**UWCD-3**

**UWCD-4**

FIGURE 2-12

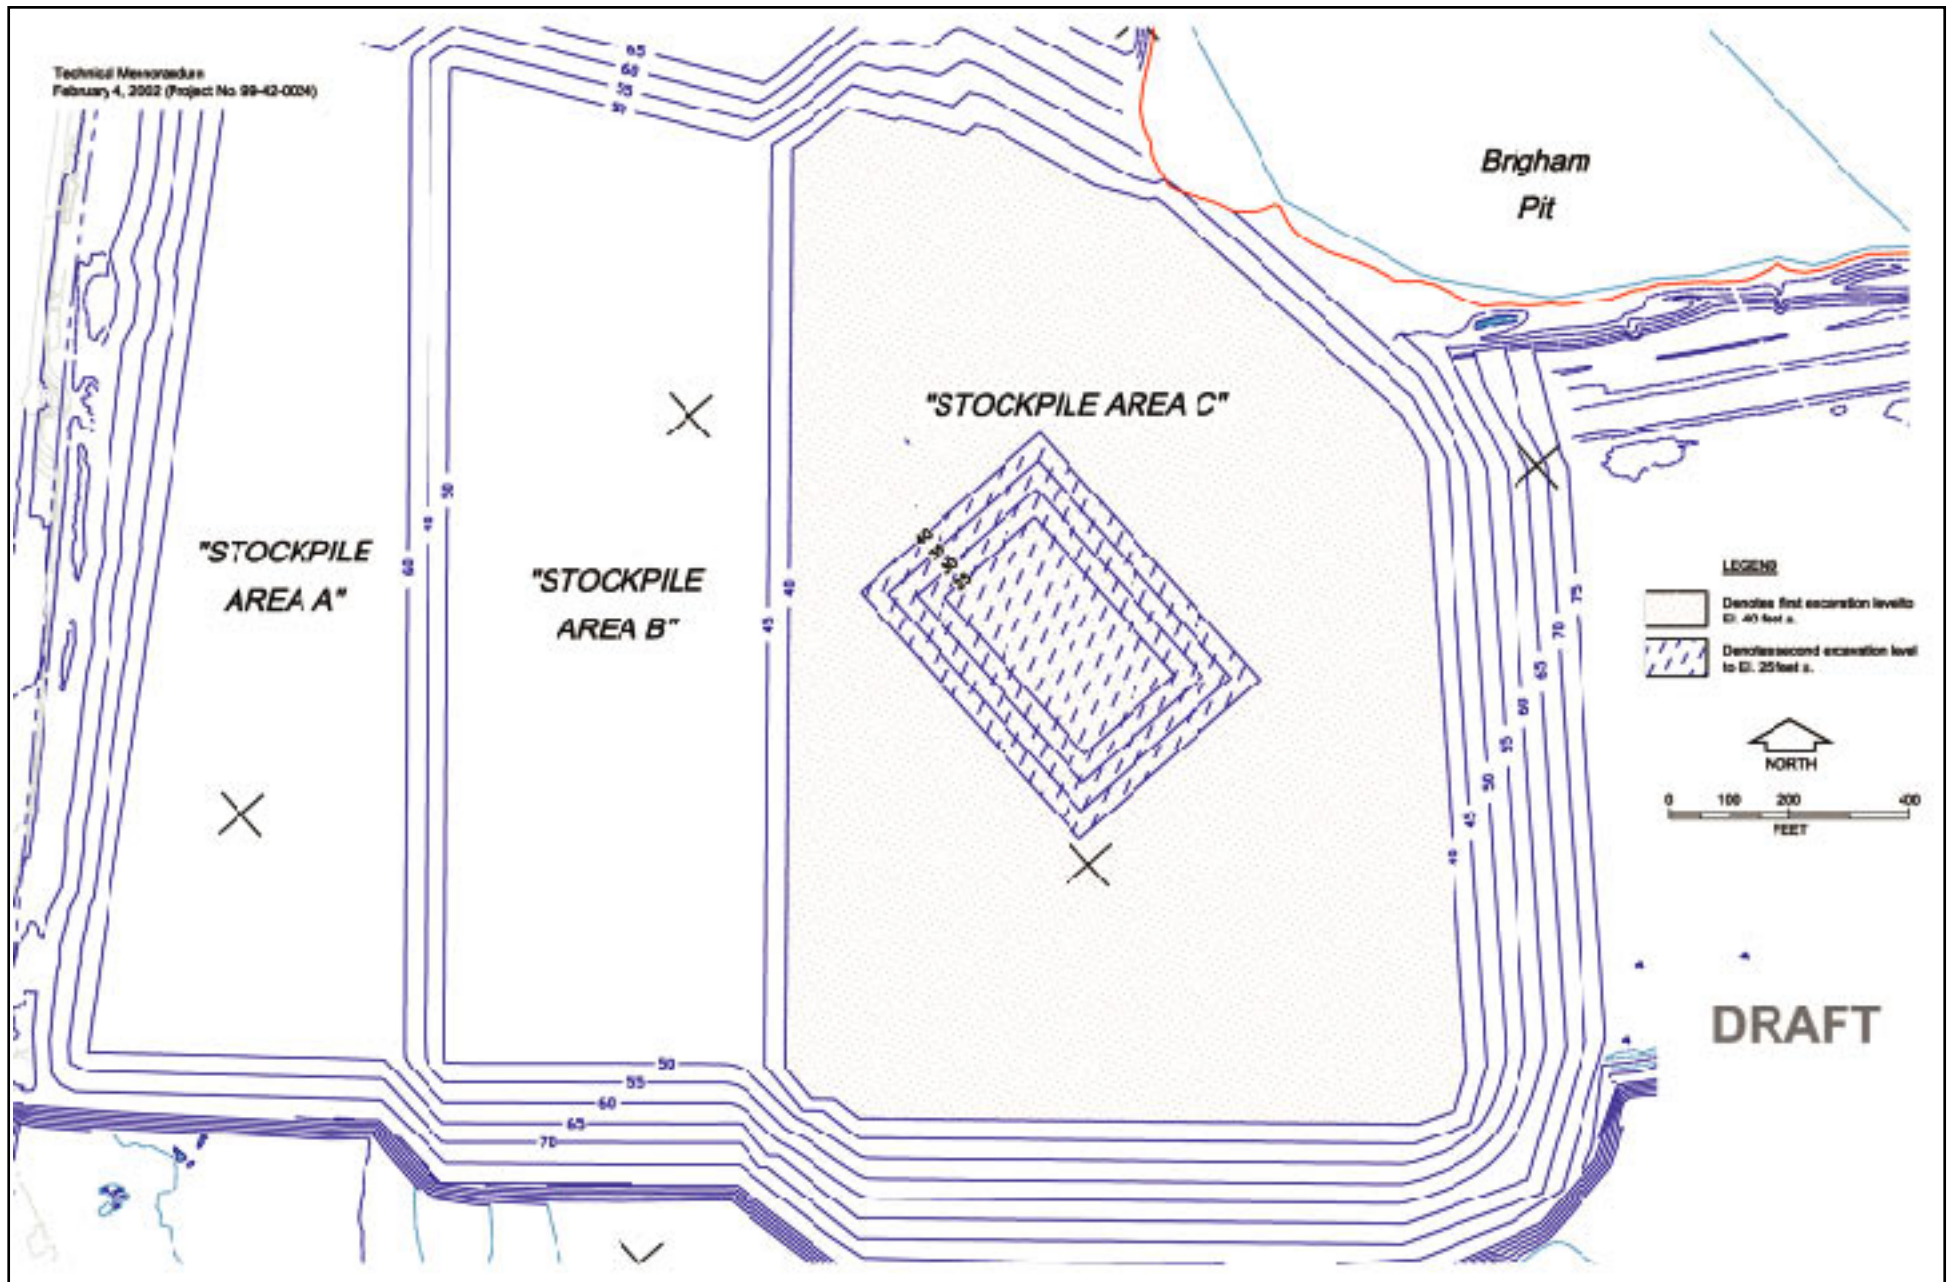
The first task associated with further evaluating the effect that the proposed dewatering operation may have on groundwater contamination associated with the Poole Oil Company Site was to clarify the proposed dewatering operation as outlined previously. In summary, the excavation estimates prepared prior to DEIR preparation (attached **Figure 2-12**) called for all of Stockpile Area C to be excavated to an elevation of 30 feet above MSL. The current conceptual excavation plan (attached **Figure 2-13**) has identified a smaller area within Stockpile Area C that requires excavation to the deepest depth, Stockpile Area D. Stockpile Area C will still need to be dewatered to reach an excavation level of 40 feet above MSL, while only Stockpile Area D requires dewatering to allow excavation to an elevation of 25 feet above MSL. The current expected excavation period has been shortened from a duration of

approximately 12 to 16 weeks mentioned in the DEIR, down to approximately eight or nine weeks. In addition, only a small portion of the Stockpile Area needs to be dewatered to the deepest depth.

FIGURE 2-14

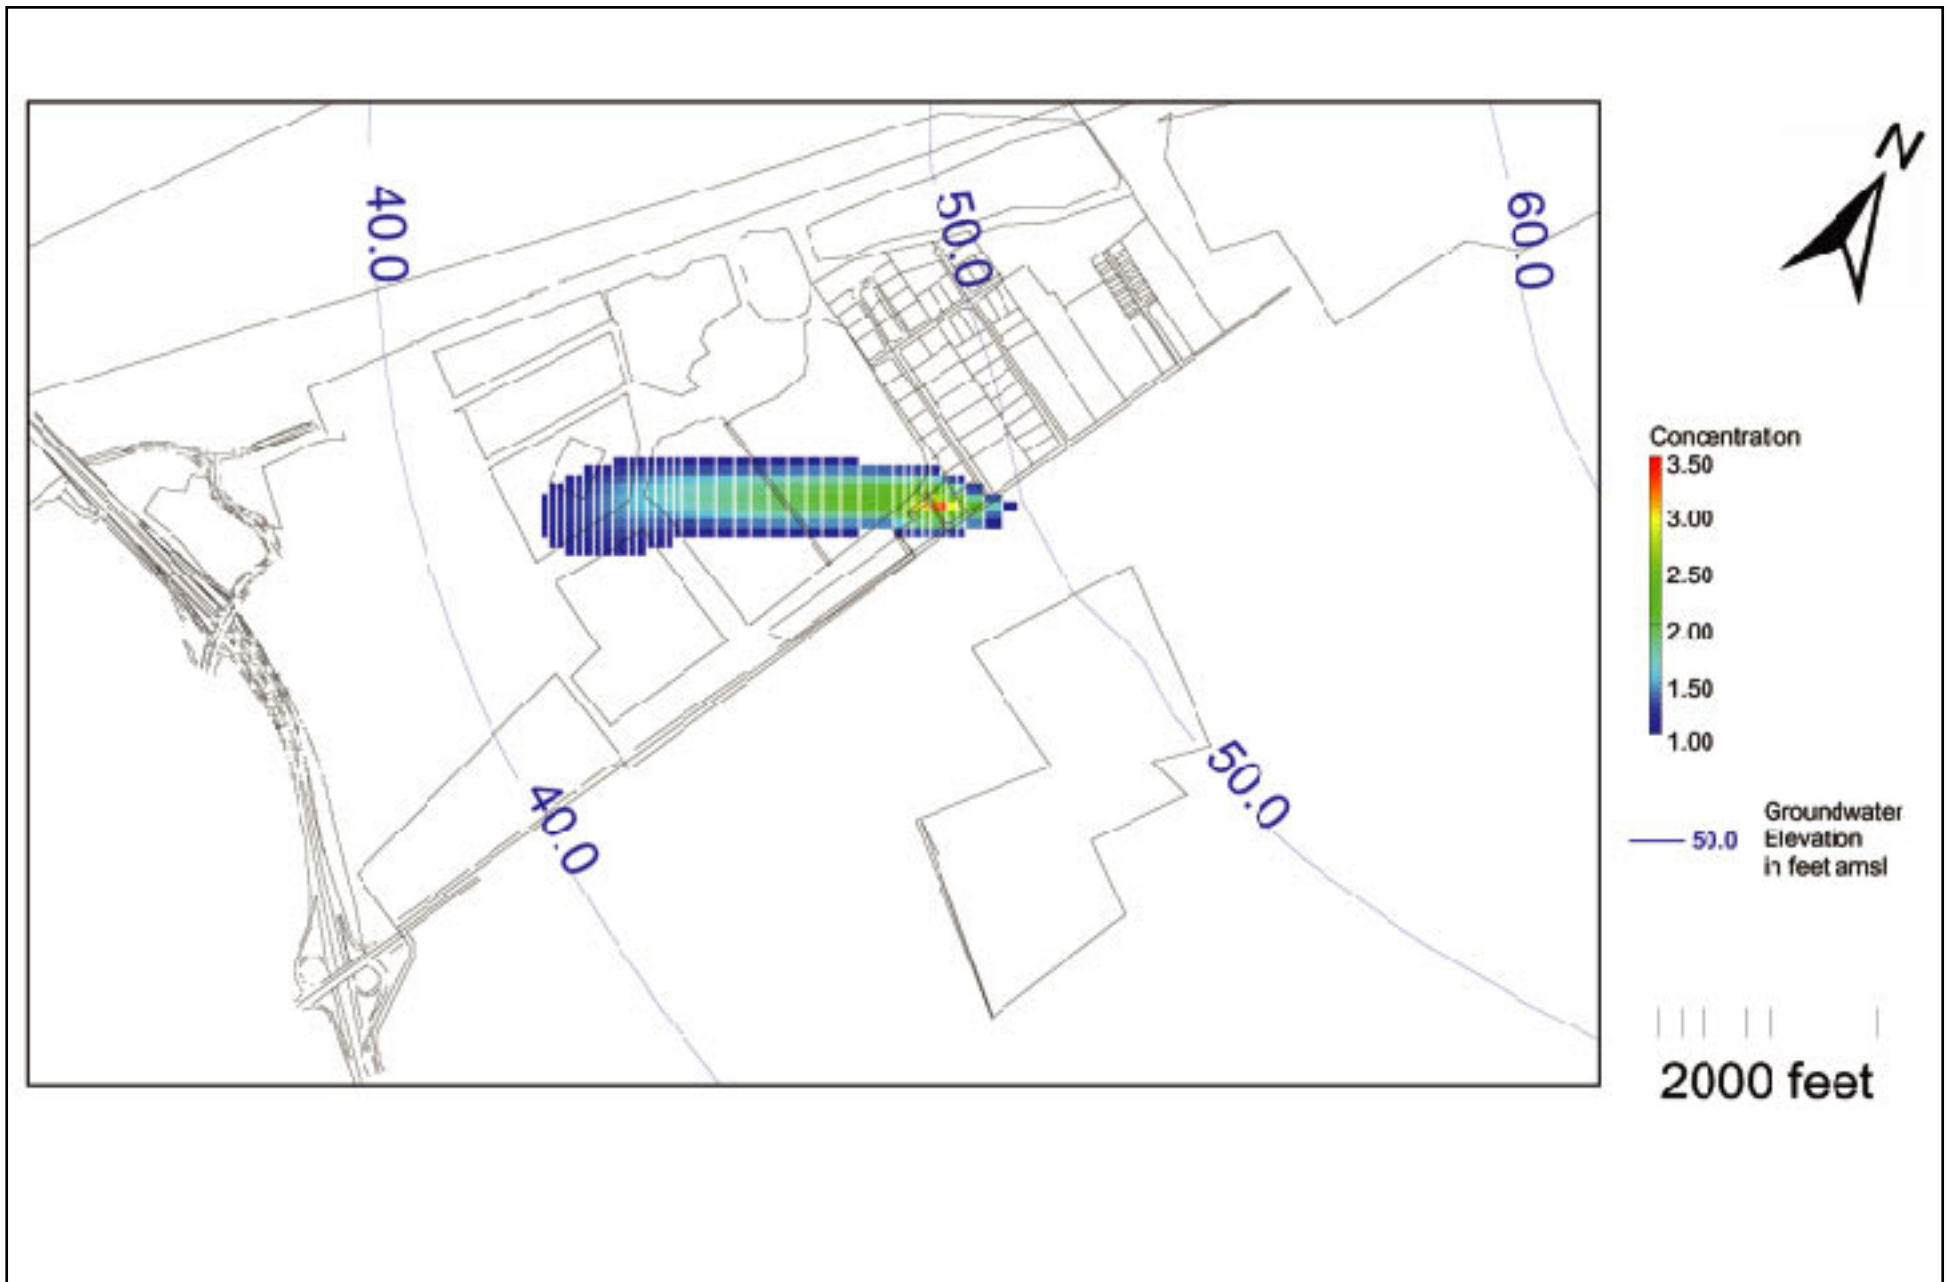
This modeling conservatively does not account for any dilution effects of the pits and also does not consider that local groundwater gradients vary dramatically from season to season and from year to year in the Forebay Basin over a standard water year (see Fugro (2001) Figure 3: Water level hydrograph for State Well No. 2N/22W-22H1). The baseline scenario indicates that the contamination from the Poole Oil Company Site would migrate approximately 3,400 feet downgradient (attached **Figure 2-14**) in one year, under ambient conditions.

FIGURE 2-16

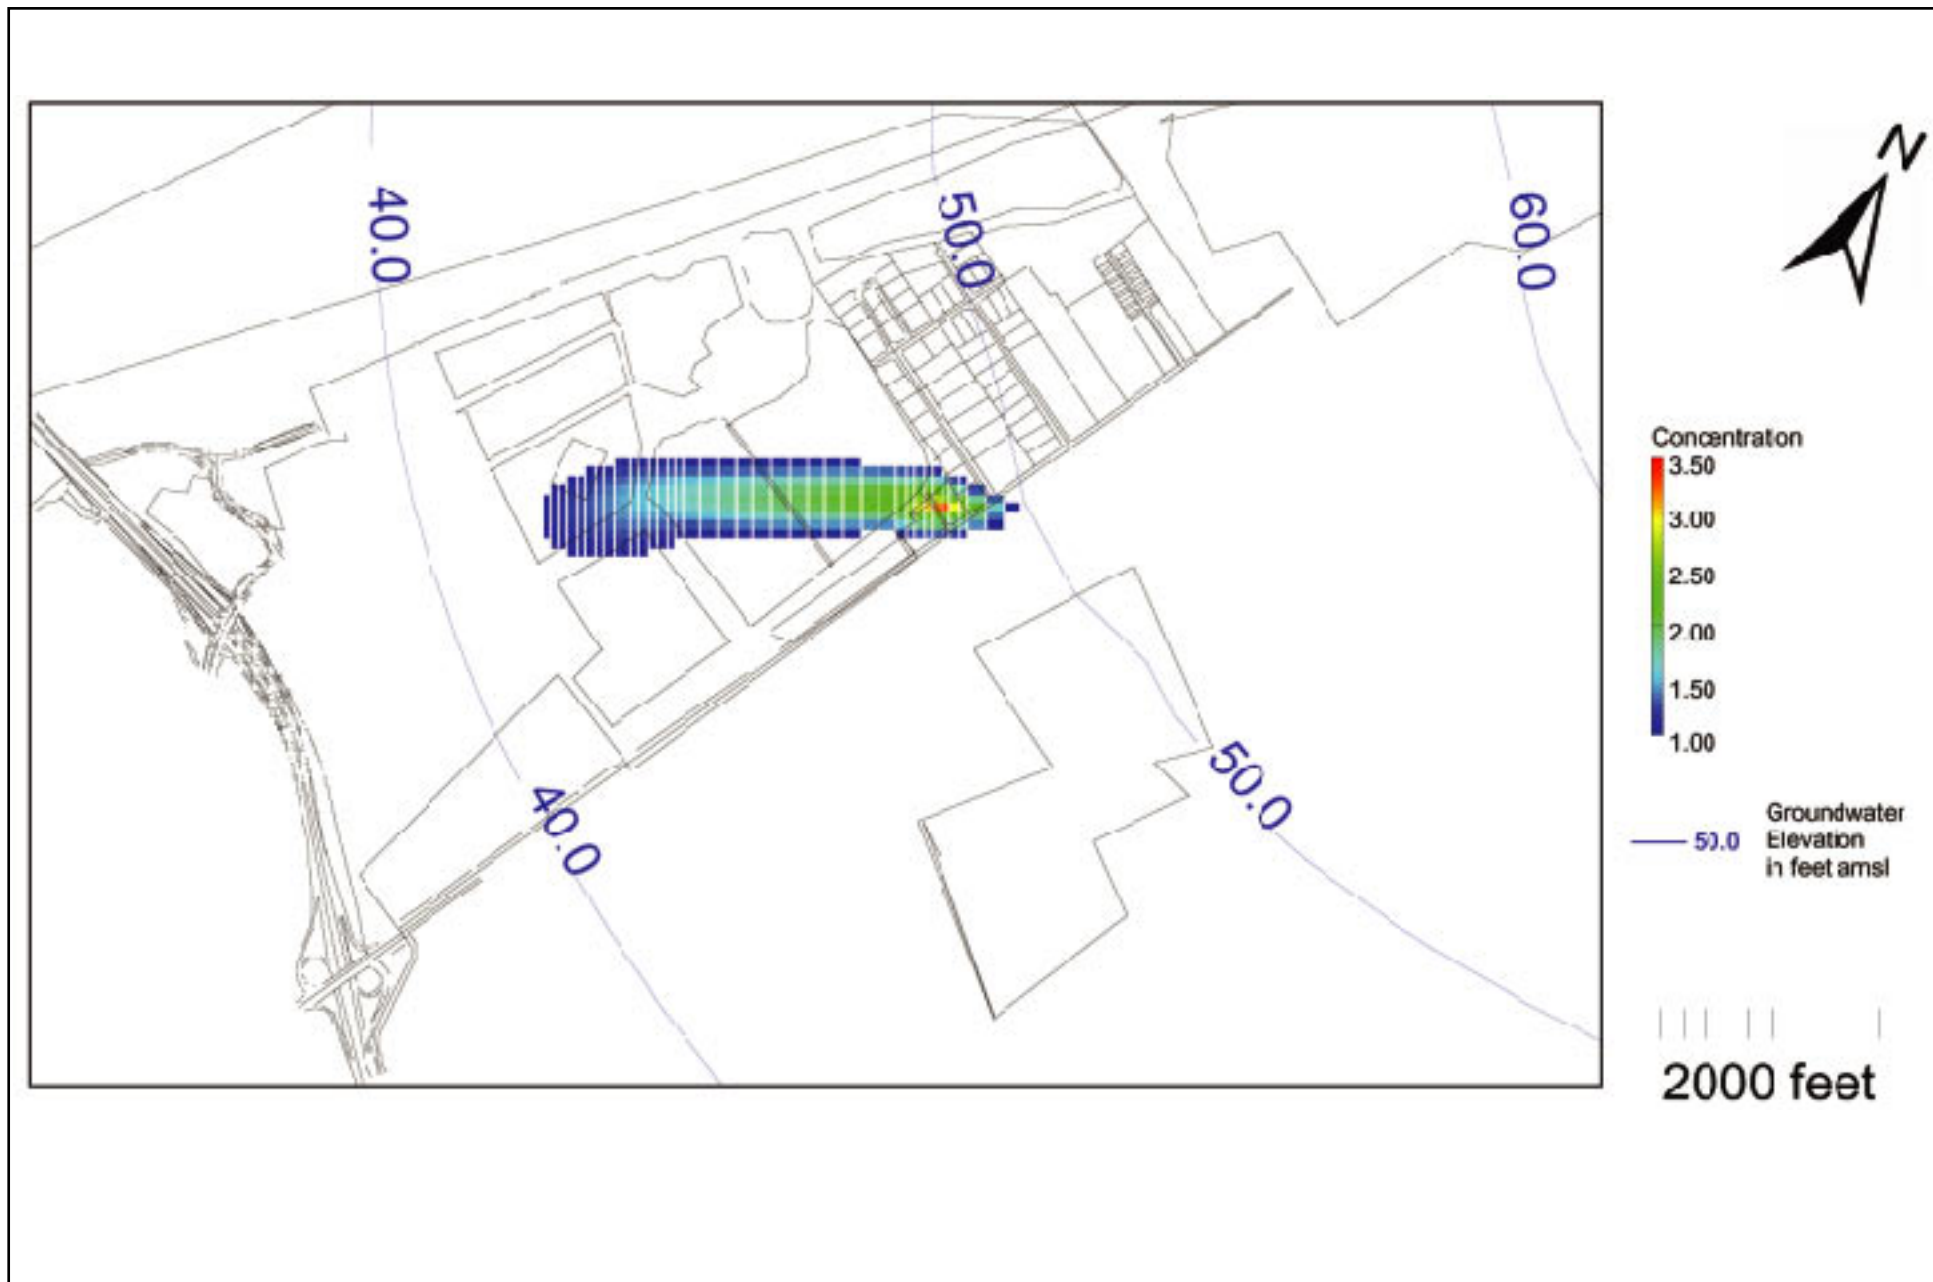
The result of the baseline scenario indicates that relative capture of the groundwater contamination is possible (see attached **Figure 2-16**). The scenario that includes one-year of recharge to the Pits indicates that even though approximately 6,000 acre-feet are recharged to the northwest of the Poole Oil Site, the extent of contamination is almost identical to the baseline condition (see attached **Figure 2-17**).

The threshold for a significant groundwater quality impact related to the future use of the Pits for water storage and recharge is defined as displacement of the MTBE contamination from the Poole Oil Company Site substantially further than expected under ambient basin conditions. As indicated in attached **Figures 2-18** and **2-19**, a future potential use can be implemented that would not create a significant groundwater quality impact. It should be noted that the modeling scenarios conservatively assume that: there is a continuous source of contamination; the anticipated average volume of water is delivered to the Pits in the first year, instead of increasing volume in a phased manner; and, that water is delivered to all of the Pits in the first year of delivery, whereas, UWCD has expressed flexibility in the location for delivery during initiation of the use of the Pits.
